Public Information Centre #2

Summary Report

Ojibway Parkway Wildlife Crossing
Municipal Class Environmental Assessment (Phase 1 to 4)
Windsor, Ontario

City of Windsor

Preliminary Preferred Design Concept

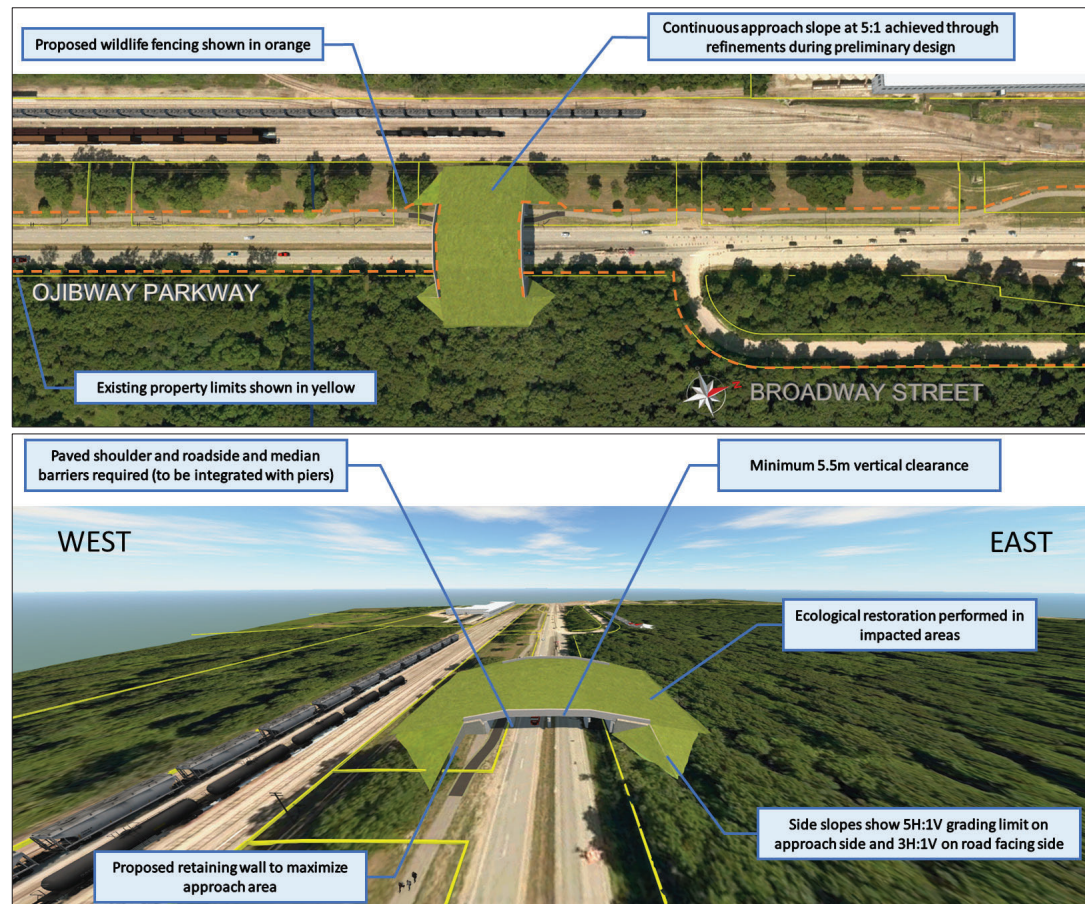
| Theme | Summary of Comments | Study Team Response |
|--|---|--|
| <p>Support for other alternative (Alternative 4), instead of the Preferred Design (Alternative 2 - Four Span Bridge)</p> | <p>Following is a summary of comments expressing support for Alternative 4 (Four Span Arch Culvert), instead of the Preferred Design (Alternative 2 - Four Span Bridge):</p> <ul style="list-style-type: none"> • It performs better than Alternative 2 in almost all categories (except for safety and drainage). • It is the most aesthetically pleasing and the only option that allows for variation in soil depth, thus accommodating a greater variety of moisture regimes and by extension plant diversity. • It has the most optimal slope for wildlife. • It will impact less terrestrial habitat than alternative 2 (3900 m2 vs. 4100 m2, respectfully), potentially contributing to the preservation of 300 m2 of a rare vegetation community. • It would allow for the barrier fencing to run directly along the Ojibway Parkway right-of way boundary, while maintaining fence continuity along either side of the crossing itself (due to the inclusion of a pedestrian tunnel). Allowing for fence placement directly adjacent the roadway would maximize the amount of natural habitat, increase cost-savings by linking with the existing fence north of Broadway Street, and increase trail user safety by eliminating the user space between a chain-link fence and Ojibway Parkway. • It has the lowest construction cost, compared to Alternative 2, resulting in a cost savings of over \$4.0 million. These substantial savings could be used to solve the pedestrian tunnel safety issue, construct under-rail crossings, and perhaps even address the documented road mortality problem on Malden Road and Matchette Road. | <p>Although Alternative 4 has least impacts / greatest benefits related to all other criteria, safety was a significant concern associated with this alternative. Windsor Police Service was consulted to solicit feedback on various alternatives.</p> <p>Please note that, as a result of the 50m long section of the adjacent multi-use trail will be completely closed off visually from the adjacent roadway. This will greatly restrict ongoing natural surveillance capability and thus increase susceptibility to the occurrence of unlawful behaviour without easy detection. In addition, emergency access to northbound and southbound lanes, as well as to the multi-use trail will be restricted.</p> |

| Theme | Summary of Comments | Study Team Response |
|--|--|--|
| <p>Suggestion for other alternative options for the crossing</p> | <p>Following is a summary of comments sharing other suggested alternative options for the crossing:</p> <ul style="list-style-type: none"> • An amended narrow overpass extension of the crossing over railway tracks with a small stone-substrate-rock treatment, as well as two vegetative strips as an added option. The concentration of wildlife here is unlike authentic wilderness overpasses in the frequency of anticipated use. • A small culvert or 2 could make this easier as well. • In the absence of an overpass spanning the rail yard, an underpass or other railroad crossing structure should be included as an additional component of this project. For example, there are two drains that cross under the rail yard to the north and south of the proposed crossing (Titcombe Rd. Drain, and Susan Drain). Can these provide safe passage for SAR turtles, either in their current state or if upgraded? A tool for the assessment of road-stream crossing for wildlife passage can be found here: https://streamcontinuity.org/naacc/assessments/terrestrialconnectivity. • Feasibility of installing simple railroad crossing structures under the rail lines should be investigated (e.g., targeted removal of ballast between existing or specialized rail ties: see Pelletier et al. 2005). To achieve the provisioning of “safe” passage for SAR snakes and turtles, the project needs to directly incorporate the best available knowledge gained from connectivity modelling and railroad ecology studies. • No alternative was considered for a road viaduct with a wildlife crossing land bridge at ground height (similar to the existing Herb Gray Parkway wildlife crossing or to have a wider Ojibway Wildlife Crossing that allows for a human path as well). | <p>Thank you for your feedback. As presented at Public Information Centre #1, a Wildlife Overpass was identified as the preferred solution as part of the Phase 2 of the Municipal Class Environmental Assessment process for this project. Accordingly, various technically feasible alternative design concepts were identified and evaluated to identify a preferred design for the Wildlife Overpass.</p> |

| Theme | Summary of Comments | Study Team Response |
|---|---|--|
| | <ul style="list-style-type: none"> No alternative was considered for a combination (partially) sunken road viaduct with a less heightened overhead Wildlife Crossing land bridge. | |
